# Access Compliance Report

### (Curb Ramps)

Intersection ID: 12761	Main Street: S_MINT_ST	Cross Street: W_CARSON_BV	Location: W
ADA ID: F6F475F5C9B7	Ramp Type: PerpDiag	Initial Pass/Fail: Fail	Overall Compliance: No
Severity Score: 12.5			
Codes/Mitigation Info/Possible Solution		Field Measurements/Component Compliance

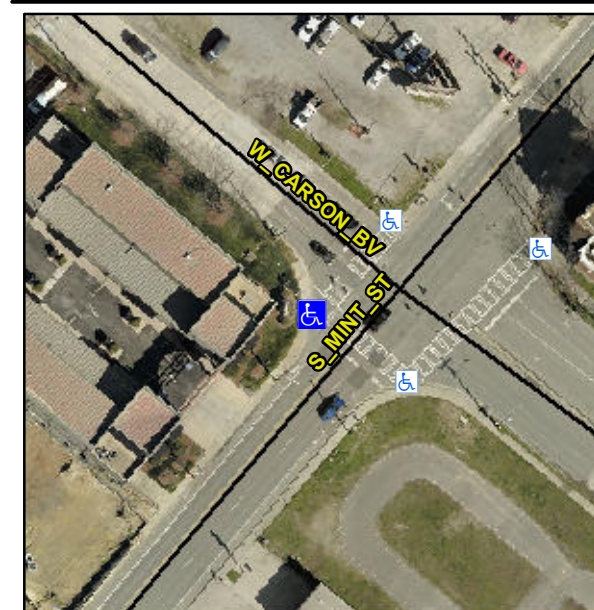
Compliance	Description	Data	Compliance	Description	Data
N/A	Ramp Length (in)	53.0	No	Ramp Slope (%)	9.1
Yes	Ramp Width (in)	48.0	Yes	Ramp XSlope (%)	0.6
N/A	Flare Type LT	N/A	N/A	Flare Type RT	N/A
N/A	Flare Slope LT (%)	N/A	N/A	Flare Slope RT (%)	N/A
N/A	Flare Traversable LT?	N/A	N/A	Flare Traversable RT?	N/A
N/A	Landing Length (in)	N/A	N/A	DWS Provided?	N/A
N/A	Landing Width (in)	N/A	N/A	DWS Contrast?	N/A
N/A	Landing Slope (%)	N/A	N/A	DWS Length (in)	N/A
N/A	Landing X Slope (%)	N/A	N/A	DWS Full Width?	N/A
N/A	Landing Curb? (Y/N)	N/A	N/A	DWS Offset (in)	N/A
N/A	Shared Landing?	N/A			
N/A	Gutter Ponding?	N/A	N/A	Gutter Slope (%)	N/A
N/A	Gutter Lip Ht (in)	N/A	N/A	Gutter X Slope (%)	N/A
N/A	Painted X Walk1?	Yes	N/A	Painted X Walk2?	Yes
	X Walk 1 Direction	To SE		X Walk 2 Direction	To NE
N/A	X Walk 1 Width (in)	110.0	N/A	X Walk 2 Width (in)	110.0
	X Walk 1 Slope (%)	2.9		X Walk 2 Slope (%)	1.3
	X Walk 1 X Slope (%)	0.1		X Walk 2 X Slope (%)	0.4

N/A	Ramp inside XWalk1?	Yes	N/A	Ramp inside XWalk2?	No
	Road Slope (%)	0.5	N/A	Clear Space?	N/A
	Road X Slope (%)	2.0	N/A	Clear Space to XWalk (in)	N/A
N/A	Any Obstructions?	N/A	N/A	Storm Grate/Utility Hazard?	N/A
	Obstruction Type			Storm Grate/Utility Type	
		N/A			N/A
		Yes		Surface Condition? (G/P)	Good

**Remove & Replace Curb Ramp With Two New Directional Ramps or Equivalent. Restripe Crosswalk.**
